**DA NO:** DA-2024/106

**ADDRESS:** 57-69 STRATHALLEN AVENUE, NORTHBRIDGE

**PROPOSAL:** SUPPLEMENTARY REPORT  
INTEGRATED DEVELOPMENT – DEMOLITION OF EXISTING STRUCTURES AND EXCAVATION WORKS AND CONSTRUCTION OF SHOP TOP HOUSING CONSISTING OF RETAIL TENANCIES, RESIDENTIAL APARTMENTS, BASEMENT CAR PARKING, LANDSCAPING AND ASSOCIATED.

## ATTACHMENT 1: SUPPLEMENTARY ASSESSMENT

Figure 2 – Extract of viewpoint from the living room of Unit 214 with the FSR-complying envelope in cyan with red outline. The view gain compared to that of the proposal considered by SNPP at their meeting on 4 June 2025 is shown in yellow.

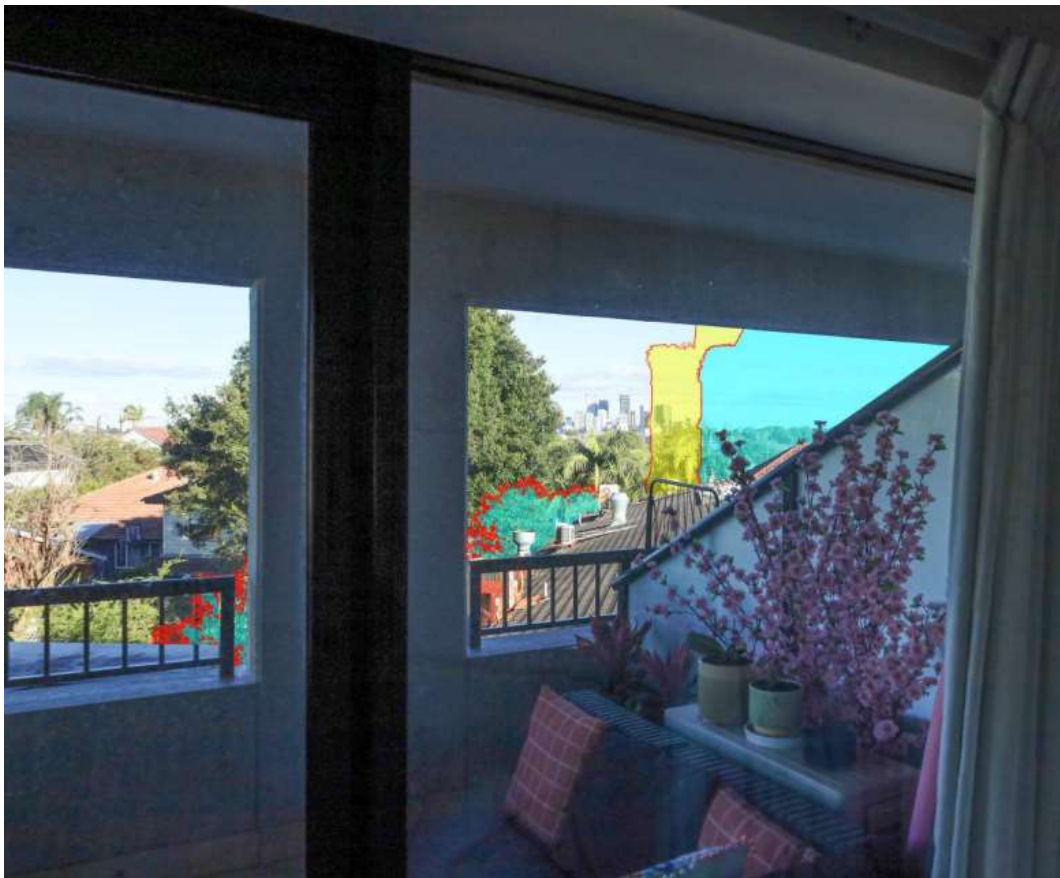
To provide the comparison requested by the SNPP, the VIA assessed the view impact of an FSR-compliant building, designed by the Applicant's architect. Figures 1 to 4 below show the view gain resulting from an FSR-complying envelope. The FSR complying envelope is depicted in cyan with a red outline, while the view gain relative to the proposal reviewed by the SNPP on 4 June 2025, is shown in yellow.

The figures below also show how the proposal's continued height exceedances from the lift overruns contribute only to the loss of sky views, which are marked with black dashed lines.

Given the Tenacity Planning Principles, the FSR-complying envelope is inherently more reasonable than the proposal reviewed by the SNPP on 4 June 2025. This is because reducing the eastern extent of the building at 57 Strathallen Avenue creates a wider view corridor from No. 128 Sailors Bay Road towards the highly valued North Sydney and CBD skylines which allows for a more equitable sharing of views.

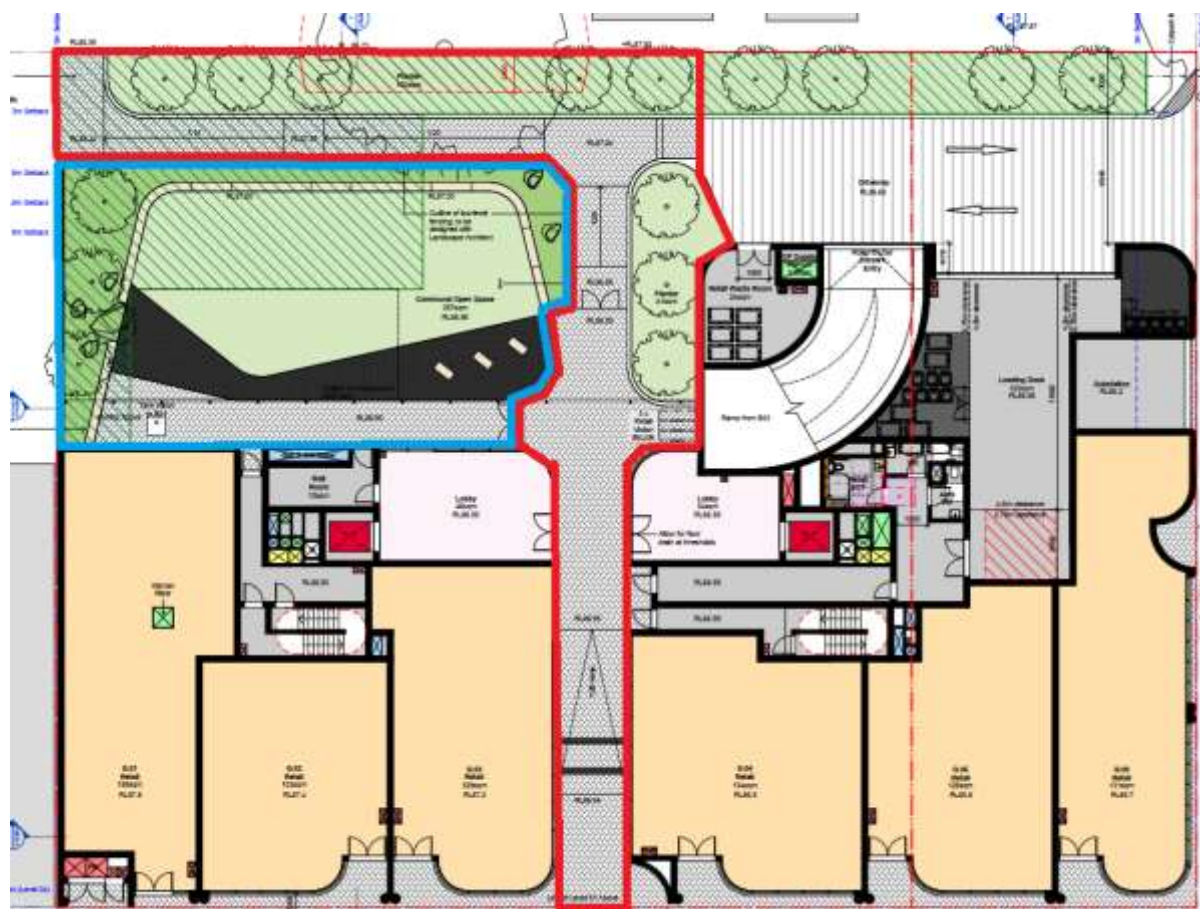
However, the Applicant's plans propose an L-shaped through-site link connecting Strathallen Avenue with Sailors Bay Road, as shown in Figure 8 below. This differs from the masterplan's alignment, which aims for a future north/south connection between Baringa Road and Sailors Bay Road.

The SNPP previously expressed concerns that the communal open space area would serve a dual purpose with the public through-site link.

The Applicant has since revised the proposal. While the communal open space layout remains as originally planned, the area initially designated for the through-site link will serve as a turfed space for residents' passive recreation until its eventual dedication as a public link.

Until this dedication occurs, the communal open space will be for residents' use only, measuring 632m<sup>2</sup> (26% of the site area), which complies with the ADG's 25% requirement.

However, once a portion is dedicated for the L-shaped through-site link, the communal open space will reduce to 357m<sup>2</sup> (14.7% of the site area), falling below the ADG's 25% requirement.

Should the through-site link eventuate in the future, the Applicant proposes the following condition of consent that would require the Applicant (or future owner) to deliver the link at that time.

*An easement is to be registered on title over the area identified as a potential through-site link within the communal open space. This easement shall be dormant until such time that a connection to 134 Sailors Bay Road is facilitated through future redevelopment.*

*In the event the through-site link is required in the future, the applicant (or future owner) must be responsible for retrofitting the communal open space area to provide a publicly accessible, functional, and compliant through-site link in accordance with Council's requirements. The design and delivery of the link is to be at no cost to Council and must ensure continued amenity for adjoining residents where practical. Details of the proposed fencing, gate and any landscaping changes are to be submitted as part of the easement documentation.*

*Upon activation of the through-site link, the remaining communal open space is to be appropriately sectioned off to maintain security and amenity for residents. This is to be achieved through the installation of a 1.8-metre high mesh pool-style fence in dark*

*colour, appropriate landscaping, and a gate to clearly define the private resident-only areas.*

*Signage is to be installed to clearly identify which areas are for resident use only and which areas are publicly accessible.*

Figure 9 – Extract of the Ground Floor General Arrangement Plan depicting the amended waste storage areas.

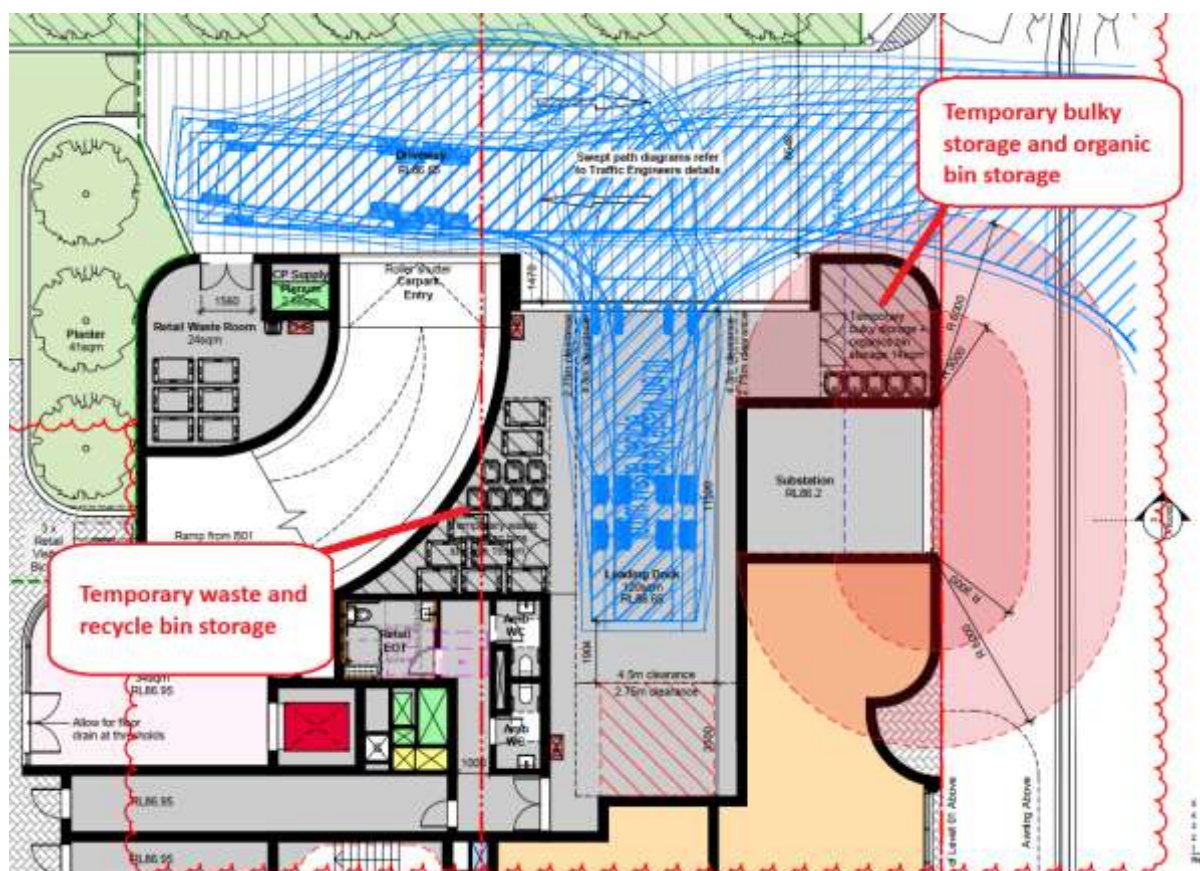
- **Council's Waste Consultant recommended that a temporary holding area for bulky waste is provided as well as bins. A suggestion was made that the organics holding room could be divided into two rooms.**

**Response:** A 12m<sup>2</sup> bulky waste room is to be provided at Basement Level 01, and a temporary loading area has also been provided at ground level for bulky goods. A 14m<sup>2</sup> holding room has been provided that accommodates bulky waste and organic bin storage.

Temporary waste and recycling waste storage is provided within a separate room, of 19 sqm, offering a total of 33 sqm holding waste space at ground level.

An extract of the Ground Level General Arrangement Plan is provided below showing the locations of the amended waste storage areas.

In their referral response dated 14 July 2025, Council's Waste Consultant has confirmed the bulky waste room has been provided and is satisfactory, subject to consent conditions.
